**High-Volume Third-Party Remanufactured
Defender Steering Box**

Strip-Down and Component Analysis

02/12/2025

Sector Shaft Condition - Not Acceptable

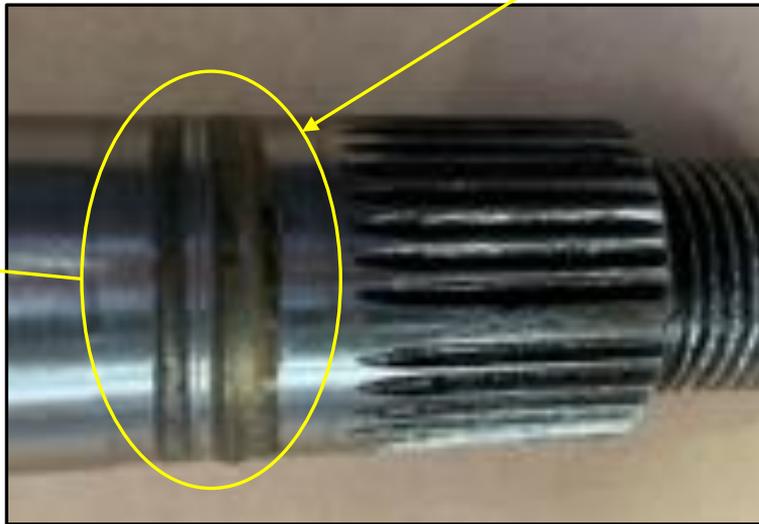
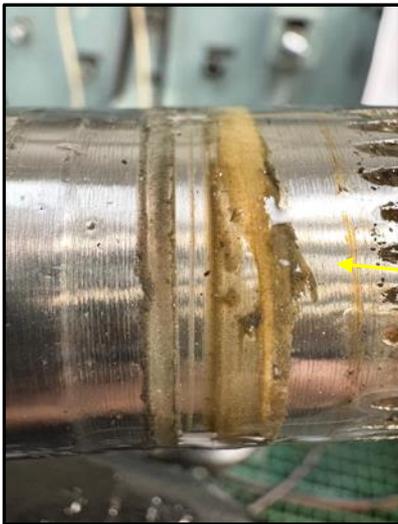
**Sector shaft long end
ground down undersize to
removed corroded area
Issue: Seal engagement
reduced**

**Box needle bearing
contact area reduced
Sealing compound used
which has hardened
assumed to increase
sealing**

Sector Shaft Output Shaft Sealing Area Ground Diameter Undersize. Practice Not Recommended For Durable Sealing

Sector Shaft Ground To Clean Up Sealing Area But The Seal used is Close to Original Sizes, Therefore Reduced Seal Engagement

Sector Shaft Condition

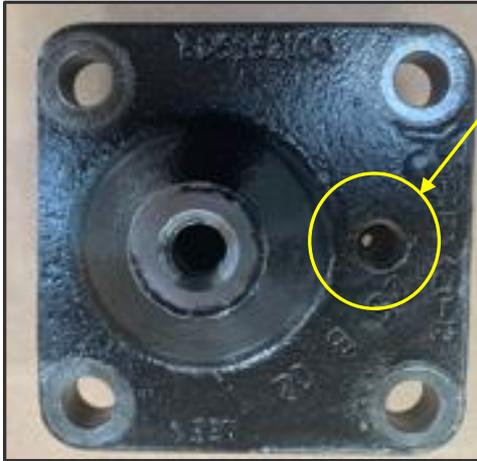
Follower Assembly No Issues

Sector Shaft Damaged Tooth. Possible Re-assembly Issue

Cover Plate Condition - Not Acceptable

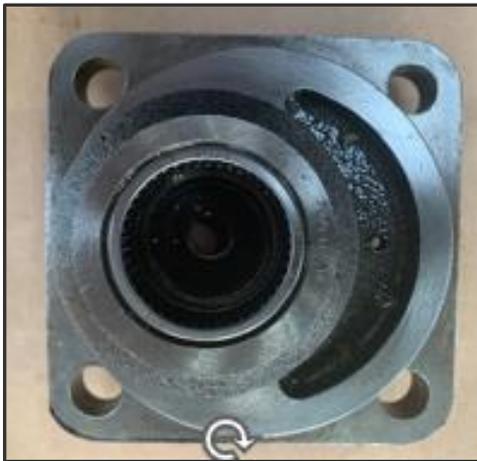
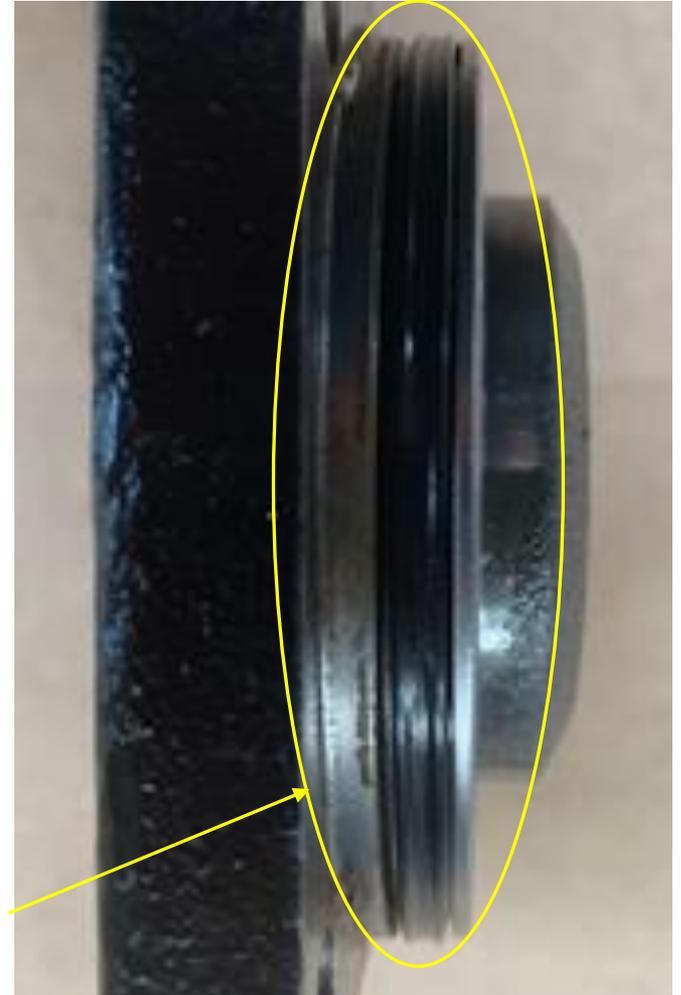
Bleed Screw and Hole Full Of Rust

Cover Plate Seal Is Not OE Specified Seal

**Square Section Seal
Is the Original Seal fitted. Not replaced With
New**

**Square Section Seal
Is the Original Seal fitted
Not replaced With New
Damaged**

Piston Rack Condition – Not Acceptable

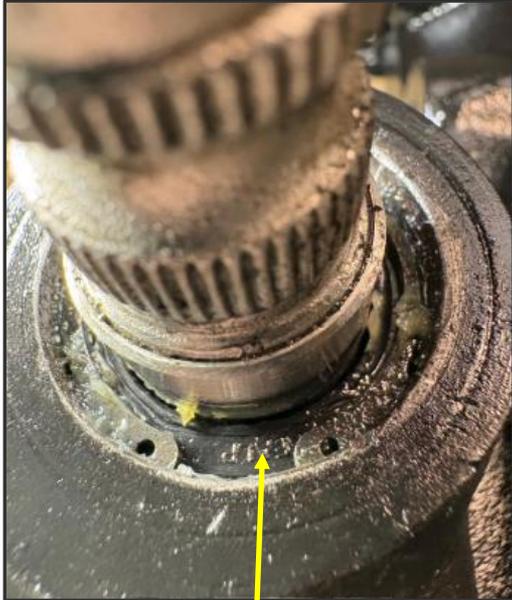
**Teflon Seal
Is the Original Seal fitted
Not replaced With New**

**Teeth Condition
Satisfactory**

**Input Seal
Damaged While
Dismantling
Therefore, No Judgment
Can Be On The Seal**

Valve Assembly Condition

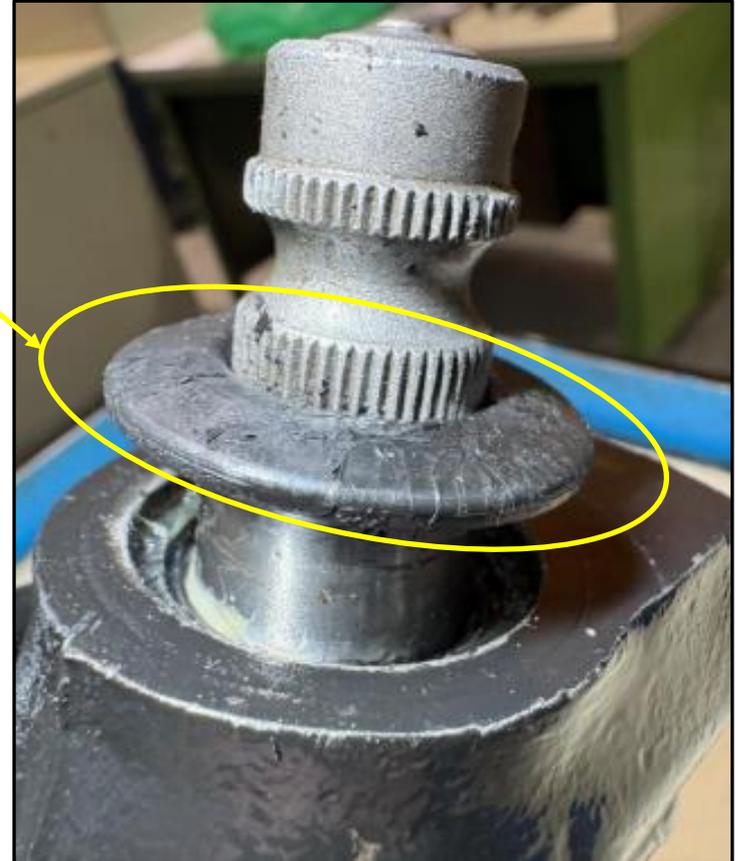
**Dirt Seal Is Not As OE
Specified
Not Acceptable**

**Valve Assembly
General Condition is
Satisfactory**

**Teflon Seals
Is the Original Seal
fitted
Not replaced With
New**

**Rack Pad Adjuster
Original Seal Fitted Not Replaced With New Seal**

Output Shaft Dirt Seal Condition – Not Acceptable

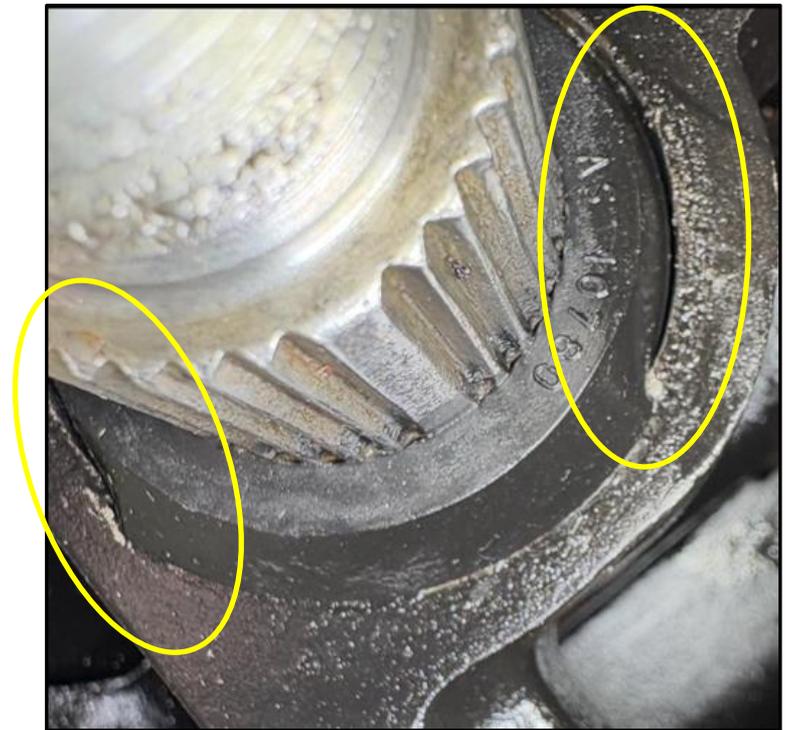
**Valve Bearing
Condition Satisfactory**

**Dirt Seal
Supplier Not Known**

**Fitment Of Dirt Seal
Not Seated Correctly Allowing Dirt Ingress**

**Sector Shaft Output Pressure Seal
Supplier Not Known
Hardened Unidentified Sealing Compound being used**

**Sector Shaft Output Backup Seal
Supplier Not Known**
